The left side is New 700929. The right side is Old 700929.

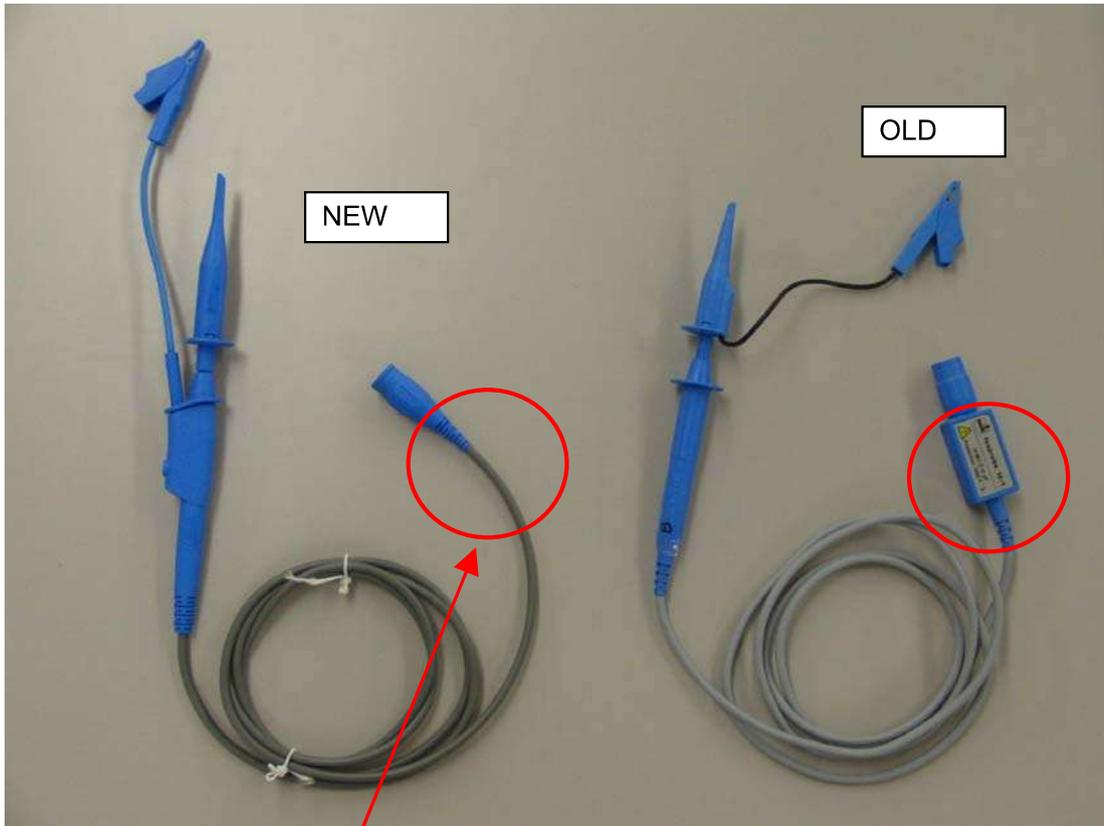
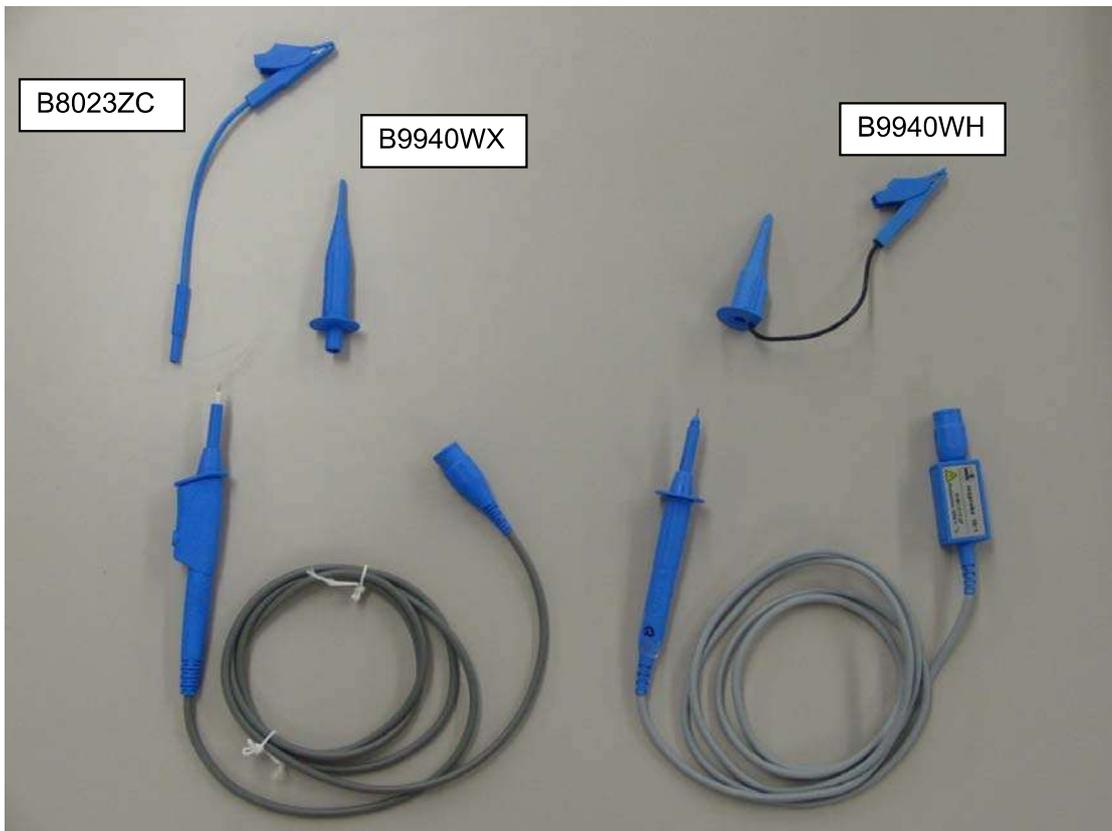
Please refer to this portion, in order to distinguish an old type and a new type.

The new 700929 has two parts, Safety pulg-on clip(B9940WX) and Safety clip lead(B8023ZC). The old 700929 has only one part, Pincher Tip(B9940WH) which has a ground lead .
